23/0571/MFUL development of former EDDC offices at Knowle, Station Rd, Sidmouth, EX10 8HL

Fig. 1 Relationship to the listed Summer House 2018

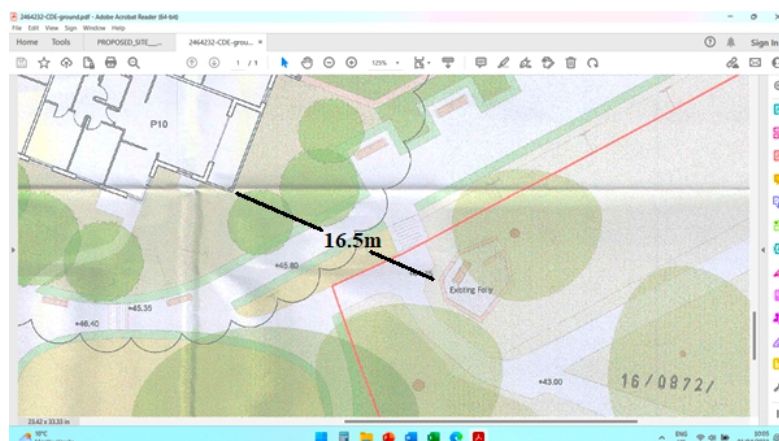
Following public consultation by Pegasus Life as they were then, the previously approved plans for the Plateau were an amended layout with Block E being moved back from its original location and rotated to reduce the visual impact on the summer house (Fig. 1).

Fig. 2 Relationship to the listed Summer House 2022

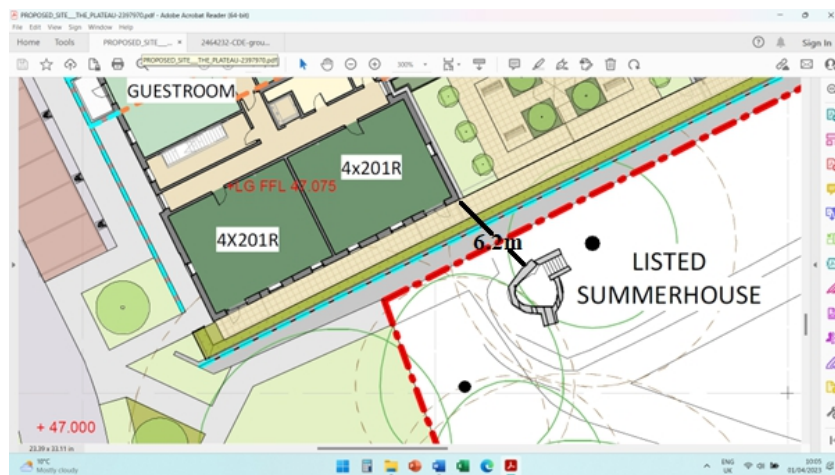
In accompanying documents, the current applicant makes much of their pre-application public consultation, but they gloss over the unfortunate fact that the majority of comments were negative and there is little evidence that they have taken anything on board. As with the application approved finally in 2018, the concerns of local people about visual domination of the garden in general and the summer house in particular were made clear by several people during McCarthy's public consultations. Yet the current plan has sited the new Block RL 10m closer to the summer house compared with the approved plan for Block E (Figs. 2, 3 & 4), and it has been turned through 45° to present a full monolithic face as a back drop to the summer house rather than a building corner with receding faces. The block has been moved to the east and now stands almost directly behind the summer house. Presumably to give more apartments a clear sea view beyond the large pine and beech trees to the south west of the summer house. The visual impact on the diminutive summer house will be enormous.

Fig. 5 South Elevation Block D 2018

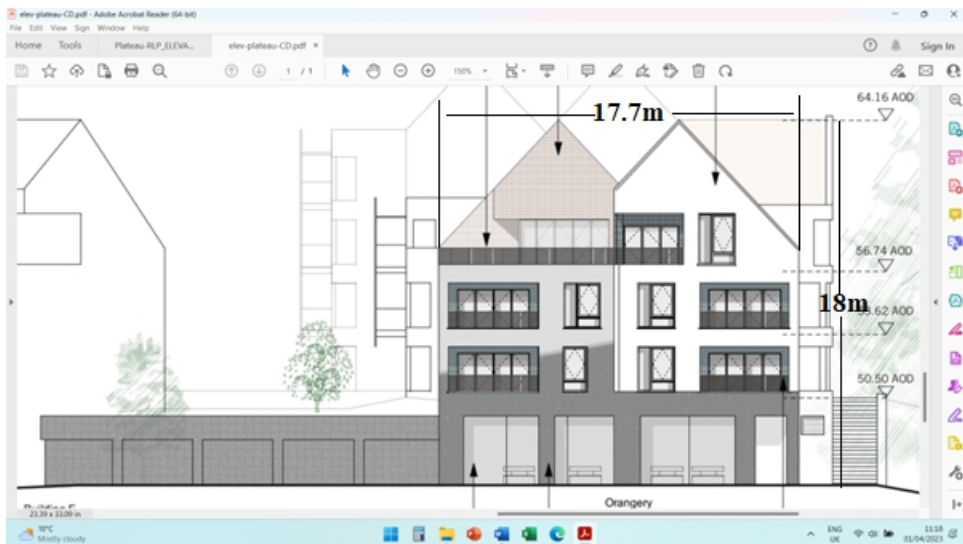
There was a lot of public opposition to the large mass of the original Pegasus-Lifestyle Block D dominating the garden area. Again the plan was modified to gain approval with the original roof profile of the south elevation being broken up with gables and a top floor open terrace (Fig. 5). There was some concern at the time that there would be a supplementary application to include another storey of apartments in the roof, but that would not have impacted on the south elevation facing the park.

This varied roof design was mentioned specifically in the appeal decision to dismiss objections of visual intrusion to long distance views from key locations such as the South West Coast Path. Paragraph 17 of the appeal decision states *"the varied roof design and height would fragment the development in such views so that it would sit comfortably within its heavily landscaped setting."*

Fig. 6 South Elevation Block RLP 2023

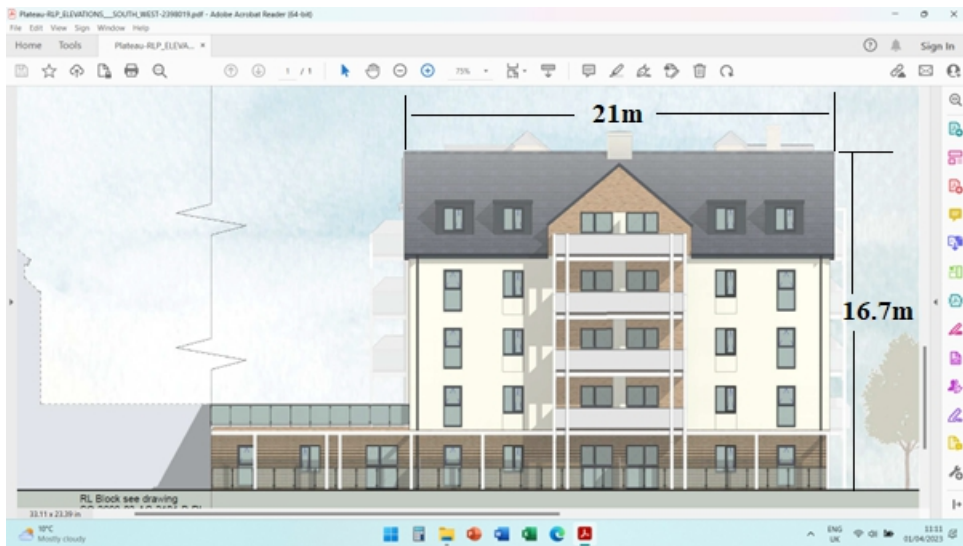
The new application for Block RLP has restored and enlarged the rectangular mass of the elevation facing onto the garden by increasing the width and turning the gable ends to the eastern and western elevations to accommodate an extra storey of apartments (Fig. 6). This elevation is a 34% increase on the built surface directly above the boundary to the garden.

Fig. 7 Relation of Blocks D 2018 & RLP 2023 to the site boundary

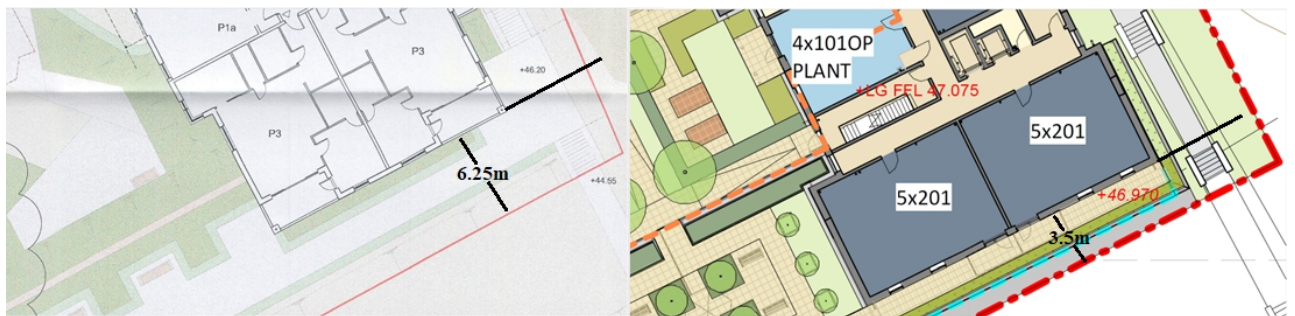
Also, the southern boundary of the block has moved even closer to the site boundary which makes the elevation even more imposing on the public park (Fig. 7). The view used in the local publicity is taken from an impossible position. It is generated very carefully to minimise the impact by being not at ground level in the garden but from a point that appears to be about 10m high up in the large Monterey Pine halfway down the garden.

Often publicity material is populated with CGI humans to give a sense of scale and make it more appealing but not in this case. I have added one of the two benches that stands on the path in front of the site boundary to the picture and a human approximately 2m tall to the same scale (Fig. 8). Perhaps McCarthy Stone could provide a CGI from that viewpoint.
